PLANNING

Client
RFU
 Project
TWICKENHAM STADIUM EAST STAND EXTENSION
 Drawing title
LEVEL 4A PLAN - NORTH

Doc ref	Project number	Drawing number	Revision
100-KSS-DR	15735	151	P02

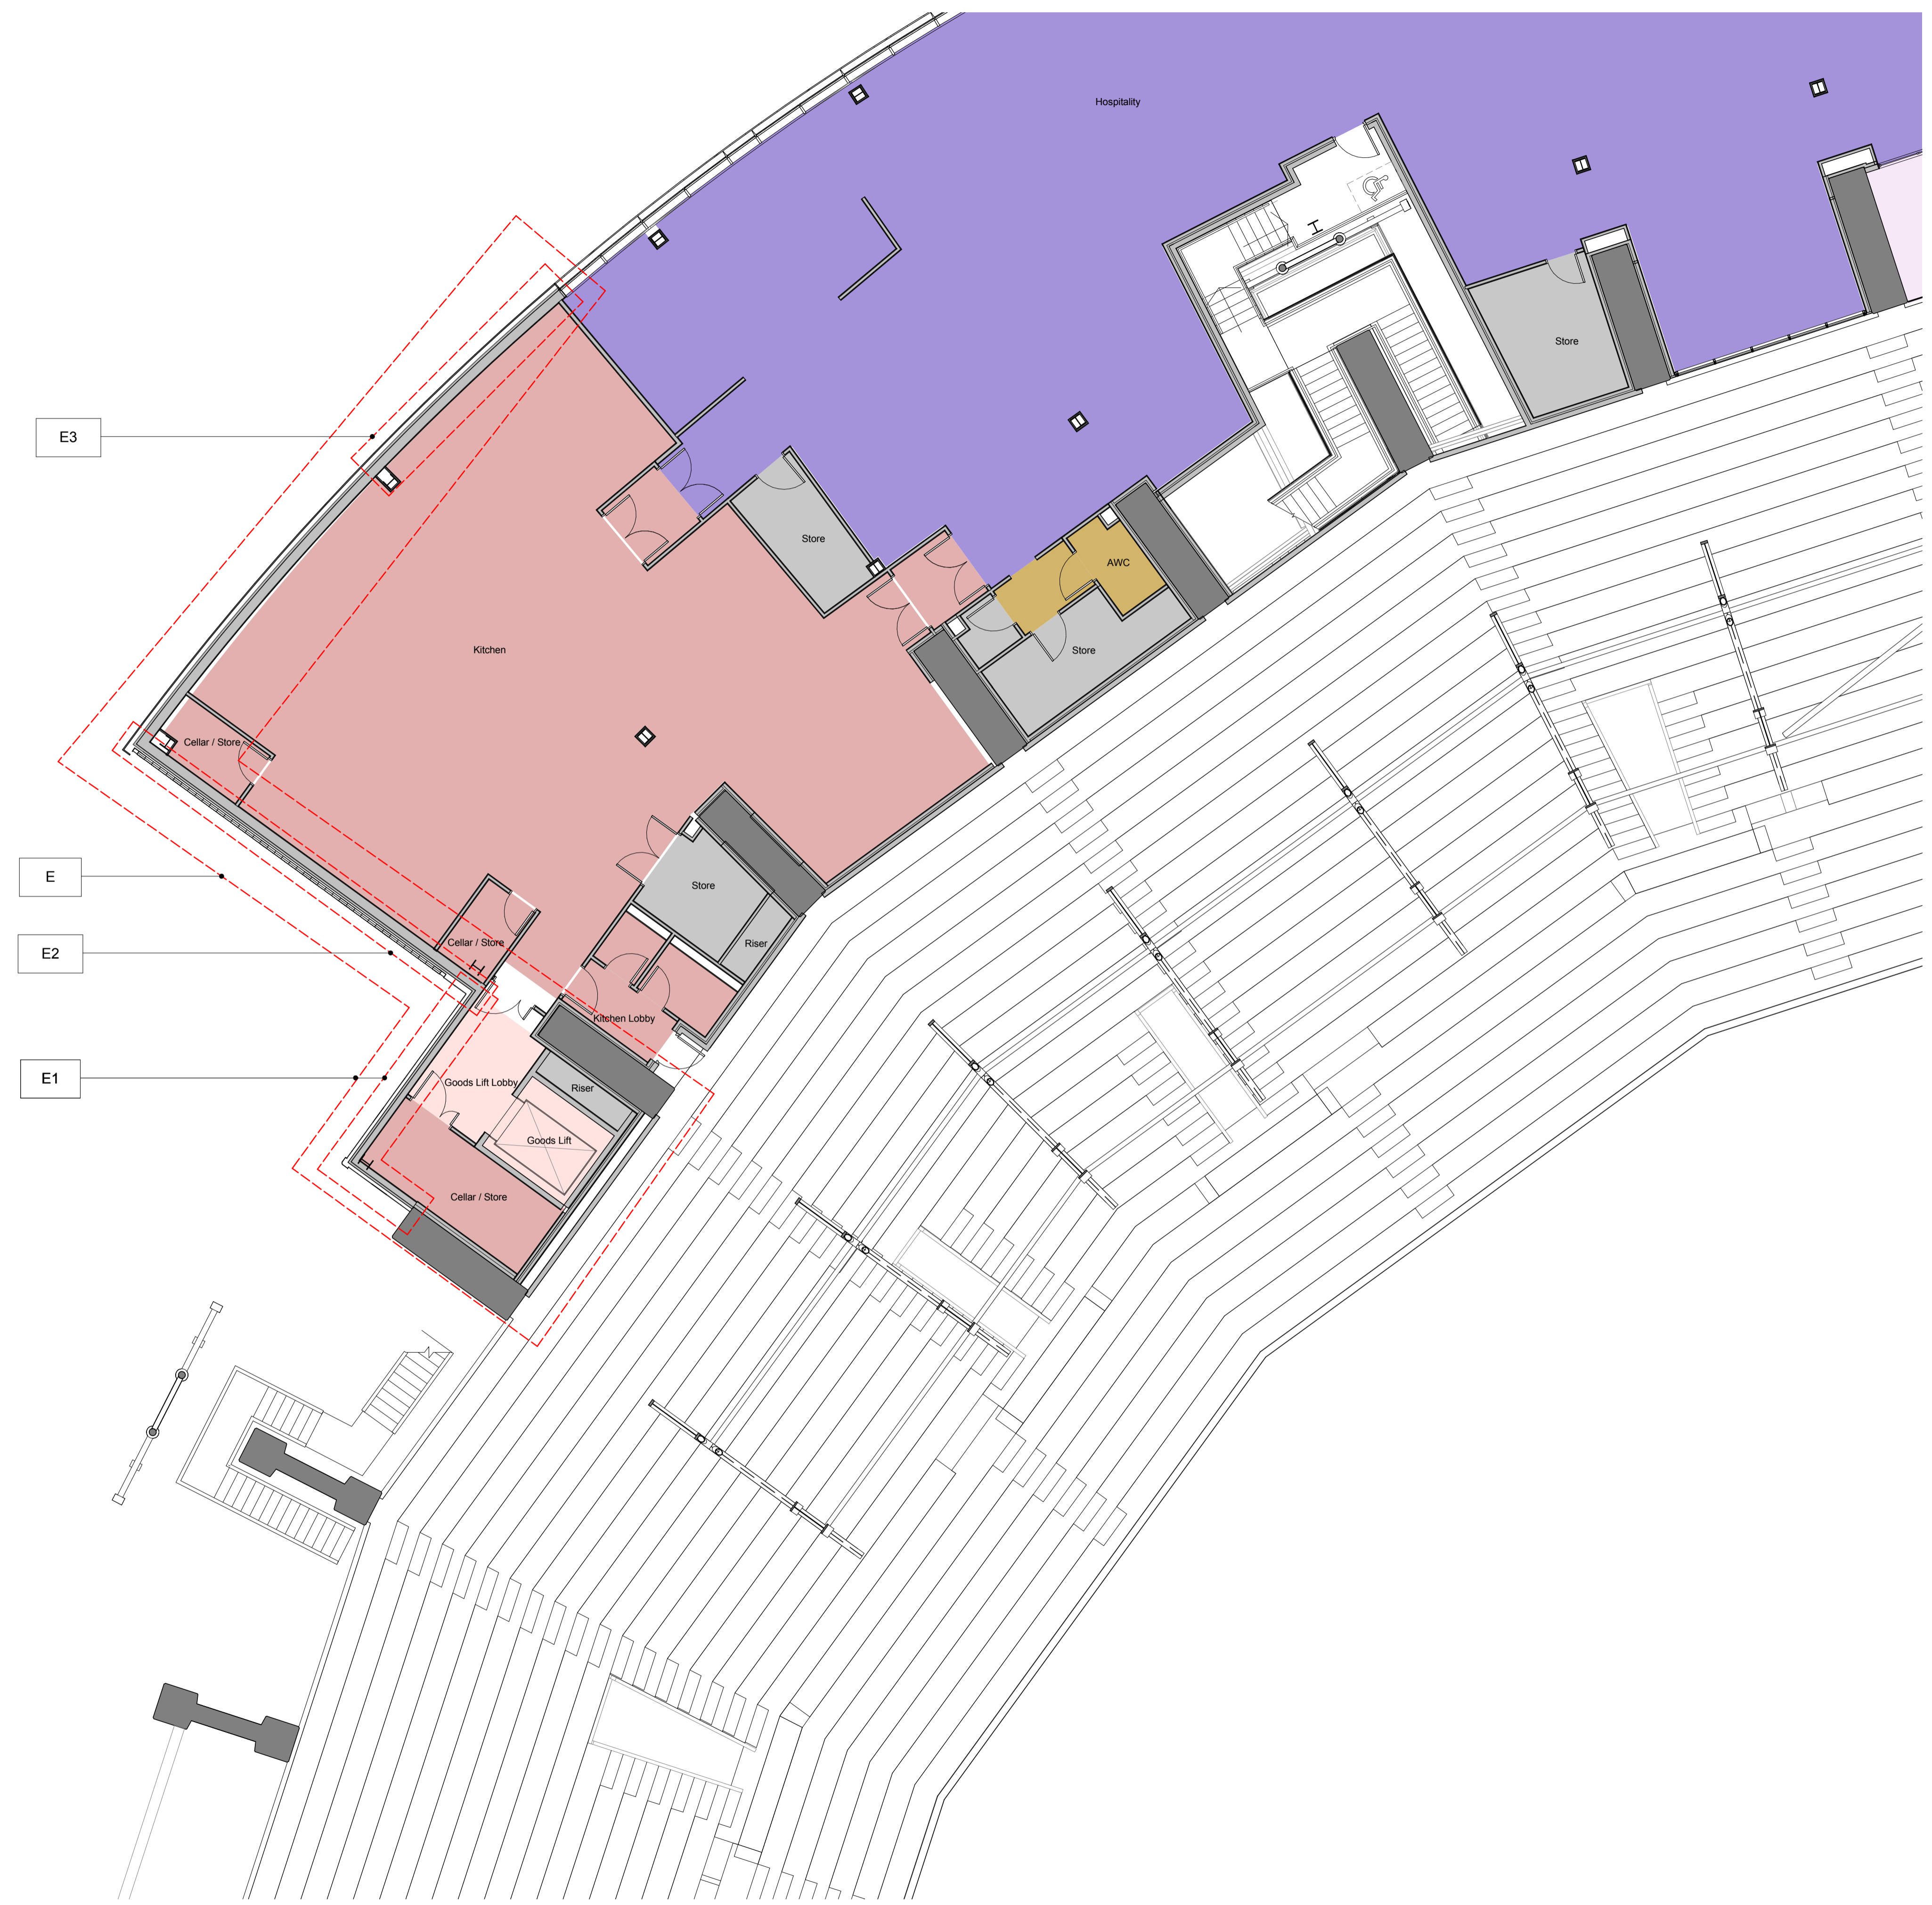
- A GENERAL AMENDMENTS TO THE SOUTH END.
- A1 INCREASED SHINGLES CLADDING AREA AND CURTAIN WALL REDUCED ACCORDINGLY.
- A2 REDUCED MASSING AND REVISED INTERFACE WITH THE SOUTH STAND.

- B PPC LOUVRES LOCATED TO THE BOWL SIDE HAVE BEEN OMITTED.
- C CURTAIN WALL SETTING OUT REVISED GENERALLY. SILICONE JOINTS TO TRANSOMS AND MULLION REPLACED WITH CAPPED SYSTEM LEVEL 04 PPC LOUVRES SETTING OUT & HEIGHT REVISED. MONORAIL FOR ABSEILING REMOVED.

- D GENERAL AMENDMENTS TO THE CENTRAL ELEVATION CANOPY AT LEVEL 5A REVISED GENERALLY AND STANDING SEAM REPLACED WITH SINGLE PLY MEMBRANE. SUPPORT COLUMNS TO ROOF CANOPY REVISED. SQUARE FASCIA TO ROOF EDGE.

- D1 LEVEL 5A GLAZED SCREEN EXTENDED IN HEIGHT AND PPC LOUVRES INCLUDED AT LOW LEVEL.
- D2 INCREASED SHINGLES CLADDING AREA AND CURTAIN WALL AREA REDUCED ACCORDINGLY. FOUR VERTICAL FINIS REMOVED.

- D3 PORCELAIN PANELS WITH SLOTTED HOLES FOR VENTILATION REPLACED WITH PPC LOUVRES. EXPRESSED HORIZONTAL PATTERN TO PORCELAIN PANELS OMITTED.
- E GENERAL AMENDMENTS TO THE NORTH END

- E1 PORCELAIN CLADDING REPLACED WITH PPC ALUMINIUM CLADDING.
- E2 GREEN WALL TO THE NORTH END EXTENDED AND PPC LOUVRES REMOVED.
- E3 INCREASED SHINGLES CLADDING AREA AND CURTAIN WALL REDUCED ACCORDINGLY.

- F FENCELINE, GATE AND PERIMETER COLUMNS SETTING OUT REVISED.
- F1 CANOPY TO TURNSTILES REVISED.
- G PORCELAIN PATTERN CHANGED FROM HORIZONTAL TO VERTICAL.

- H PORCELAIN PANELS TO THE SOFFIT OF THE ARCH REPLACED WITH PPC ALUMINIUM PANELS. PORCELAIN PANELS SETTING OUT REVISED.
- K ROOF TO LEVEL 5A (NORTH END) EXTENDED.

- L GLAZED SPANDREL PANELS REPLACED WITH METAL SPANDREL PANEL. PORCELAIN PANELS REPLACED WITH PPC ALUMINIUM CLADDING.
- L1 PPC LOUVRES INCLUDED FOR MECHANICAL VENTILATION.
